PREPARED FOR THE URBAN DESIGN COMMISSION AND PLAN COMMISSION

**Project Address:** 126 South Carroll Street  
**Application Type:** Rezoning  
**Legistar File ID #** [37800](#)  
**Prepared By:** Heather Stouder, AICP, Planning Division  
Report Includes Comments from other City Agencies, as noted

**Requested Action:** Approval of a rezoning from PD-SIP to Amended PD-SIP for the construction of a nine-story mixed-use building with 5,900 square feet of commercial space and 88 residential units.

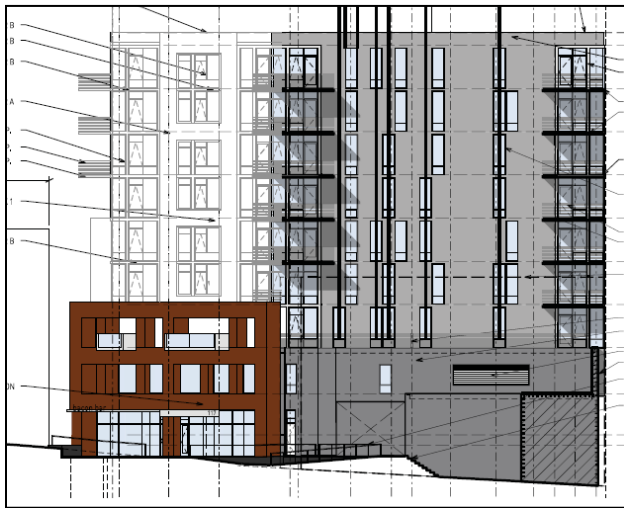
Staff believes that the proposed building is consistent with the underlying Planned Development – General Development Plan, noting that it is slightly smaller than the concept presented in 2014, since it is no longer attached to the Jackman Building. Staff generally supports the architectural direction the building has taken as well as the proposed palette of exterior materials. As discussed below, there are essentially three design details for which staff requests specific input by the Urban Design Commission:

- The use of spandrel glass on facades above the Jackman and Baskerville buildings
- Appropriateness of the balconies as proposed, and particularly of the requested encroachment for balconies in Carroll Street.
- Lack of detailed landscape plan on the third floor rooftop terrace, which would be expected for approval of a Planned Development - Specific Implementation Plan.

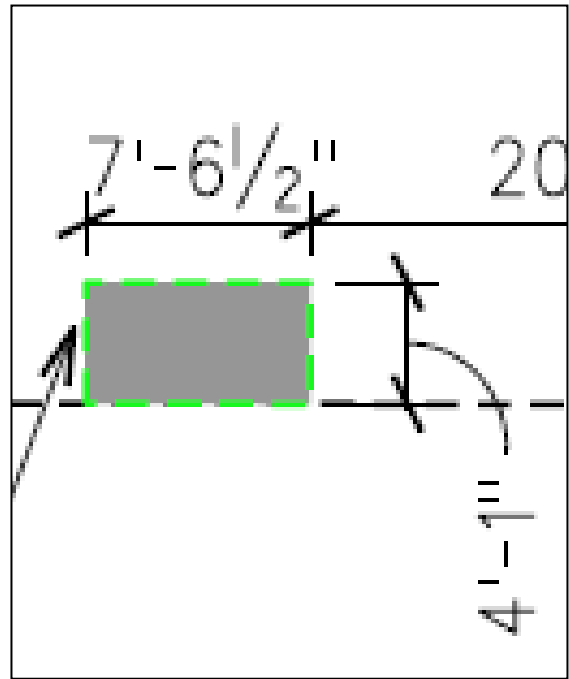
Due to the proximity of the facades to the respective property lines, many of the window panels on these two facades are false - opaque spandrel glass in front of walls and columns. The UDC should pay special attention to the detail for the proposed spandrel to ensure that it will read as a window, particularly from the long views toward these facades from both the Capitol Building and from the bottom of the hill on South Hamilton Street.
